LOT 9 PARKER POINTE

LOT 10, PARKER POINTE FILING NO. 1

COVER SHEET

SITE PLAN

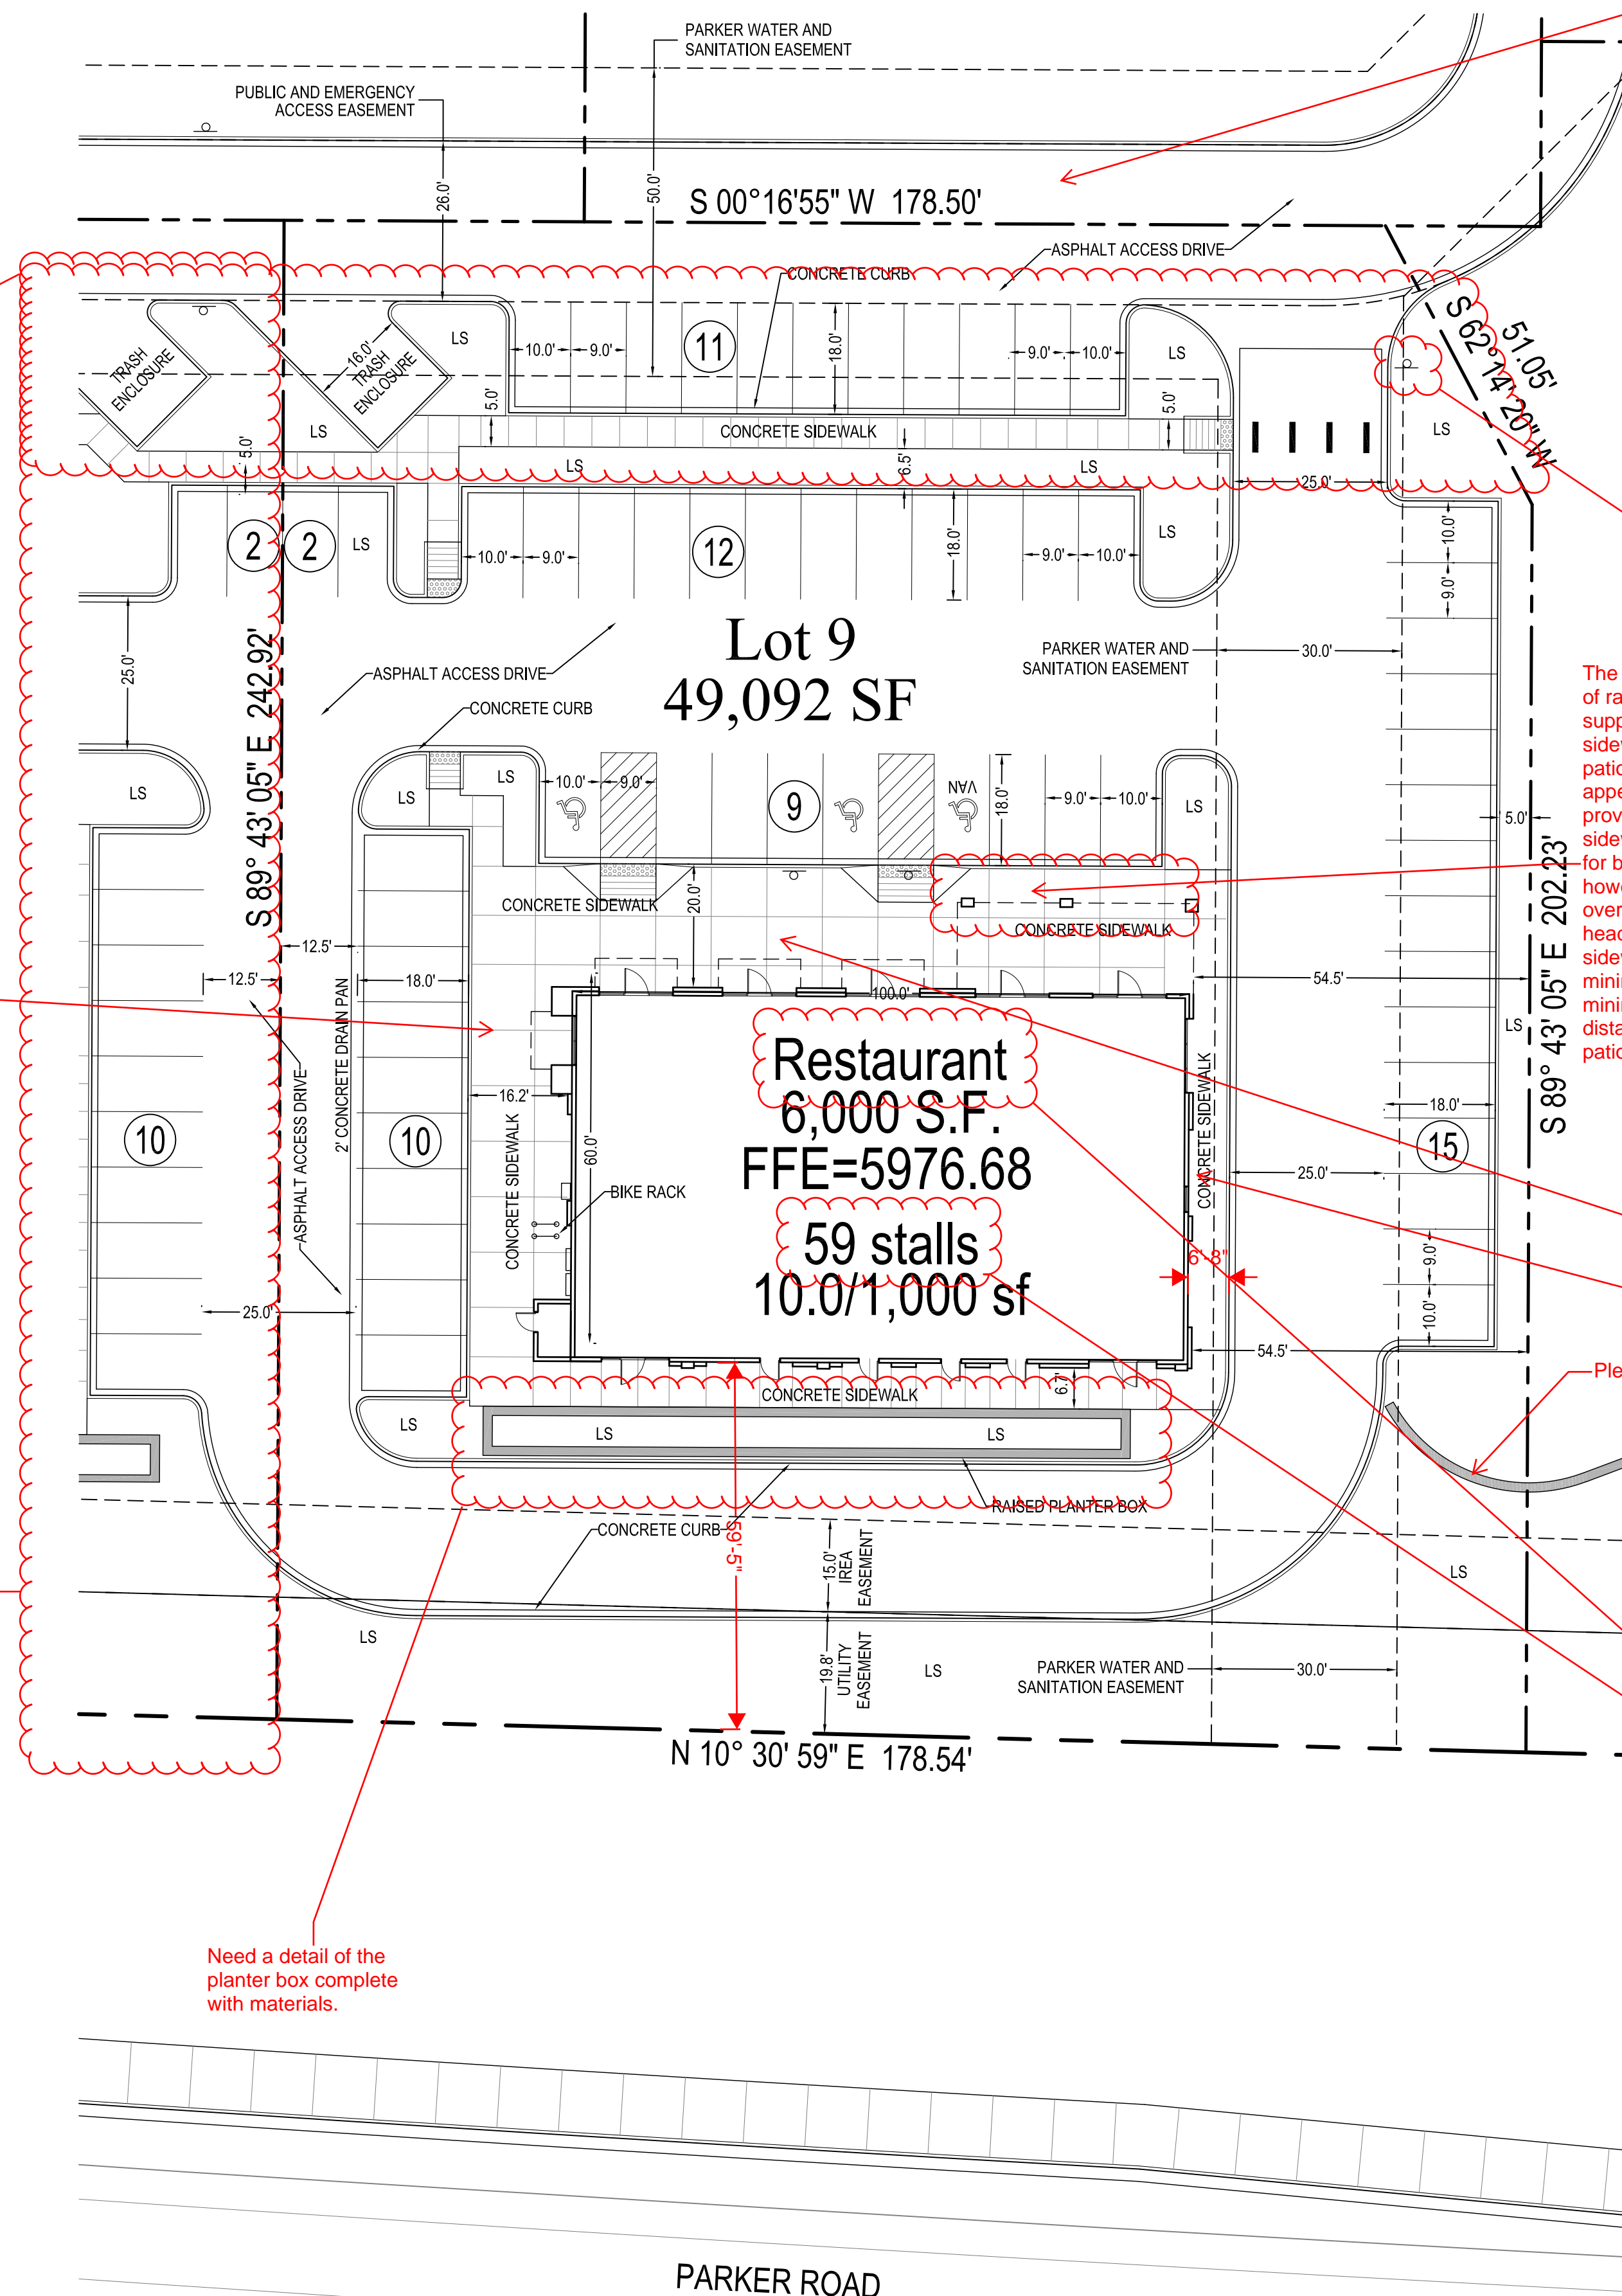
This area needs to be redesigned to include required street scape elements. (i.e. tree lawn sidewalk etc.) and to conform to a typical street frontage.

General site plan submittal requirements
Need gross, lot and net acreage for proposed use/site.
Need building dimensions.
Add names of adjacent streets
Exterior lighting locations and fixture types are not shown as required.
Show direction of travel on for access aisles and driveways.
Identify adjacent lots.

Per CI&MF
Need sidewalk connection to Parker Rd sidewalk. May use a single connection for lots 9 and 10, but connection is required to ultimately tie into Lemon Gulch trail.

Staff suggests a different layout that would pull the building closer to the western property boundary, perhaps eliminate the drive aisle, to meet setback requirements and improve the visual layout relative to Parker Rd.

Is this scoring? If so, please provide additional detail. 24" squares, 18" etc.

Gray out, not a part of this approved site plan- all sheets.
Please verify that this parking is not included on the stated spaces provided.
13.06.050(b) (6)
Number of spaces.
The total number of parking spaces required shall be the sum of spaces required for the applicable land uses individually, except if the shared parking plan and analysis clearly establish that the shared parking facility can satisfy the demands of all uses with a lesser number of parking spaces.

Need a detail of the planter box complete with materials.

This access aisle needs to look and act like a roadway. Please name it and address streetscape requirements.

Not shown anywhere on the drawing. Please clarify or remove, all sheets.

The area between the top of ramp and the patio support is very tight. The sidewalk width between the patio and the back of curb appears to be 5'. (Please provide dimensions.) 5' of sidewalk is typically required for building sidewalk, however, because of overhang resulting from head in parking, this sidewalk width must be a minimum of 7 feet. This minimum includes the distance from top of ramp to patio supports.

Need to break up 20' of concrete walkway. Perhaps the addition of curbed or raised landscape areas?

Please identify

Though the narrative and the elevations show a drive thru at this approx location, a six+ foot sidewalk is shown. Please clarify. This site plan has been reviewed based on the site plan, as opposed to the elevations and has therefore not been evaluated for a drive thru use.

Parking- As shown, this proposal is for a 6000 sf restaurant. Elevations and the narrative describe a variety of retail uses that include restaurant and drive thru restaurant. Parking requirements are calculated differently for retail than for restaurant and also are different for drive thru as opposed to non drive thru restaurants. Staff needs more information to determine if parking requirements have been met for the proposed uses. Please provide interior uses by square foot.

Not shown on site plan as required.

No proposed easement shown, please clarify or remove.

UTILITY PLAN

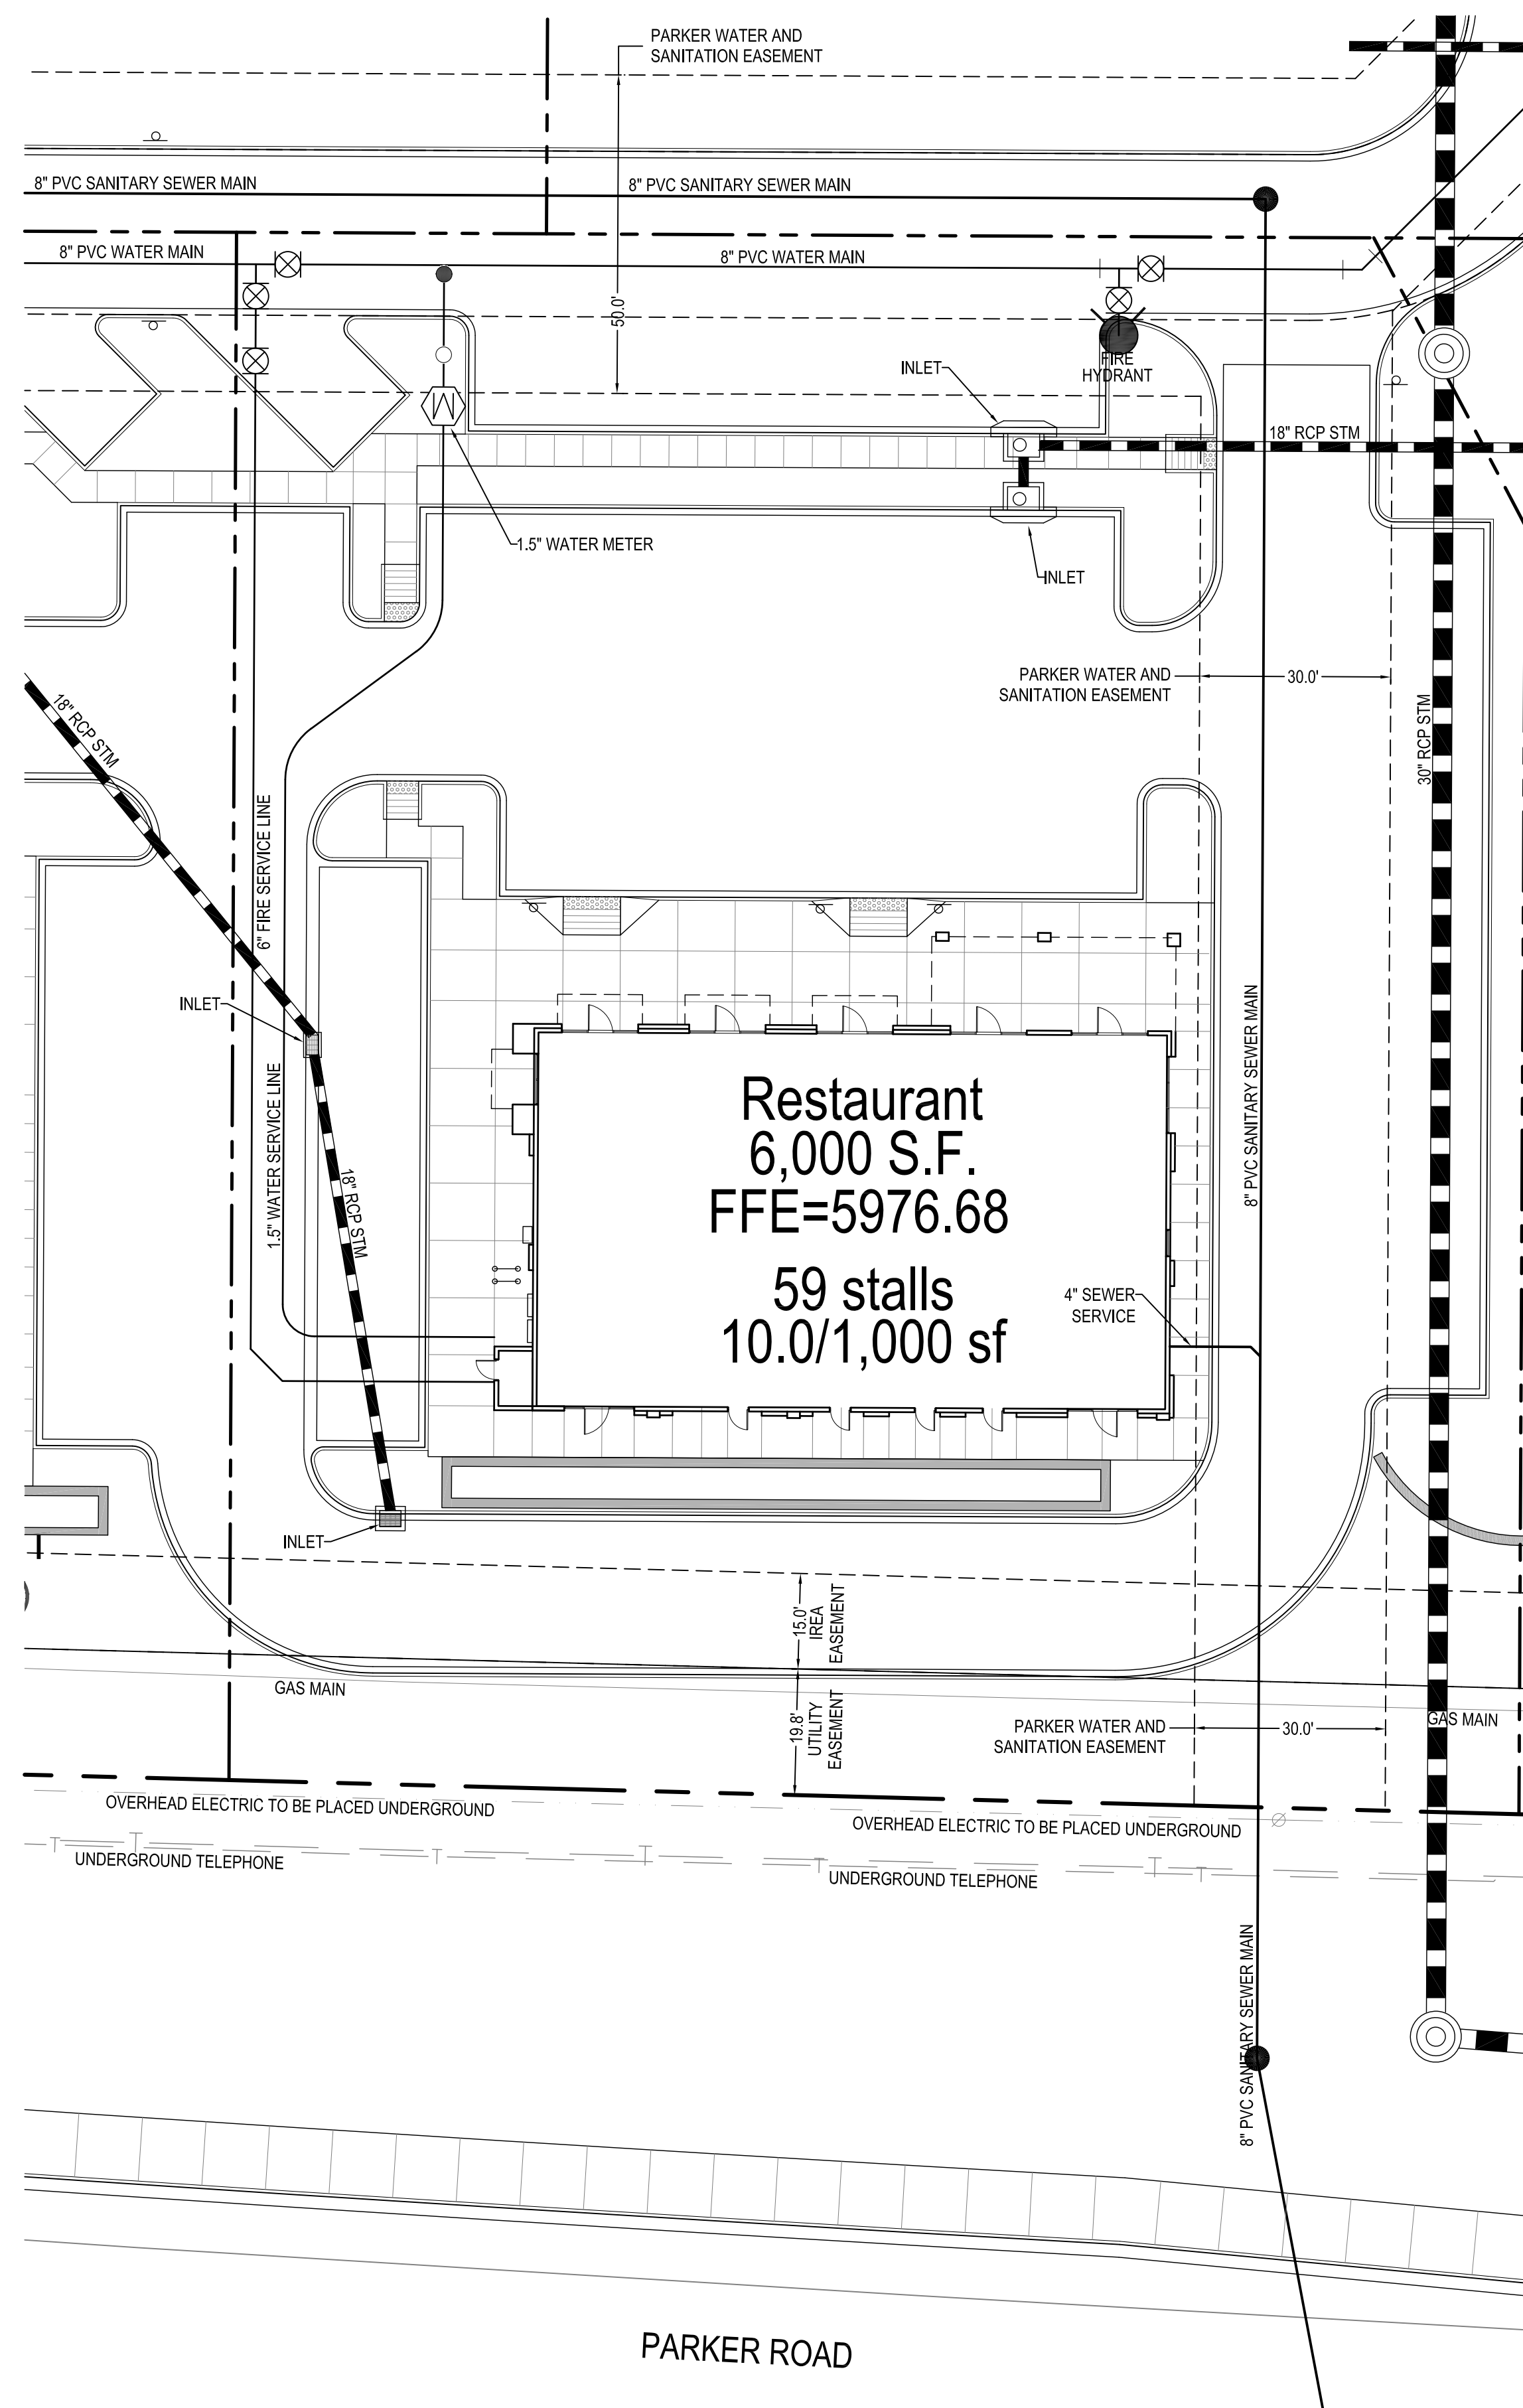
No exterior lighting shown
